**VIRGINIA ELECTRIC AND POWER COMPANY (DOMINION)
NORTH ANNA POWER STATION UNITS 1 AND 2
PROPOSED TECHNICAL SPECIFICATIONS CHANGES AND EXEMPTION
REQUEST FOR USE OF FRAMATOME ANP ADVANCED MARK-BW FUEL
REQUEST FOR ADDITIONAL INFORMATION PERTAINING TO THE ICECON
MODULES IN THE REALISTIC LARGE BREAK LOCA (RLBLOCA)**

**Request for Additional Information
ICECON Module for Containment Pressure Analysis**

**Virginia Electric and Power Company
(Dominion)
North Anna Power Station Units 1 and 2**

Figure 1 North Anna Unit 2 Case-Independent Containment Pressure Comparison

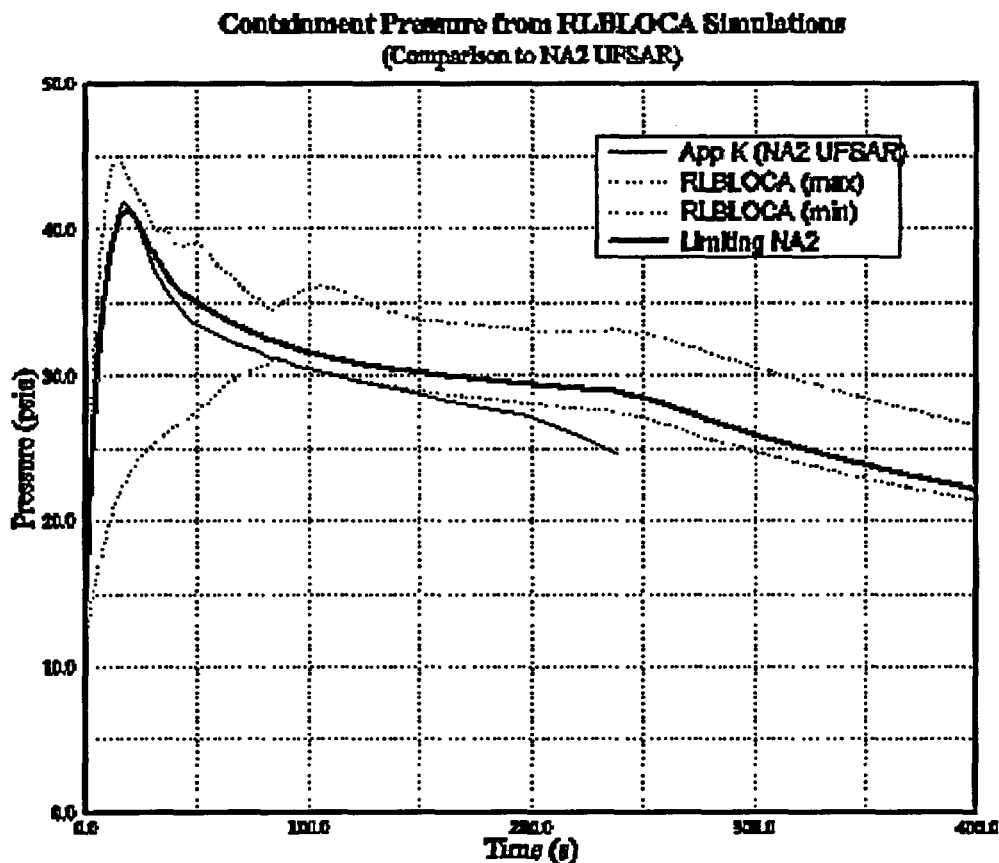
Supplemental Request: In a September 15, 2003 teleconference, NRC staff requested that results be provided to aid in demonstrating that the containment response obtained from the North Anna RLBLOCA analysis encompassed results obtained from an Appendix K-type minimum containment pressure analysis. It was determined that this could be accomplished by providing results from the North Anna Units 1 and 2 analyses that are analogous to that presented in response to RAI Question 26 on the RLBLOCA topical EMF-2103. Responding to this supplemental request eliminates the need to respond to Question 7 through 10 and Question 12.

Supplemental Response: *Figure 1 presents the containment pressure range (case-independent) from the North Anna Unit 2 RLBLOCA case set, the UFSAR (Appendix K-type) minimum containment backpressure prediction, and the containment backpressure from the limiting Unit 2 RLBLOCA case. This comparison indicates that the containment conditions, modeled in accordance with the EMF-2103 methodology, encompass a wide range of pressures, with the limiting Unit 2 case appearing near, but not at the most extreme (i.e., low pressure) value. This comparison provides insight into the relationship between ranged parameter values and PCT results from the RLBLOCA methodology. It indicates that the most limiting of the RLBLOCA PCT cases does not, in general, exhibit a value for any single ranged parameter that coincides with the most extreme value in the parameter sampled range. This is an inherent feature of the RLBLOCA methodology, and in relation to containment pressure, is distinctly different from the 10CFR50 Appendix K approach of using inputs obtained from performing a minimum backpressure analysis. Figure 1 also indicates that the containment pressure predicted from the RLBLOCA calculations encompasses a significant portion of the predicted Appendix K behavior, although this is not a requirement of the methodology.*
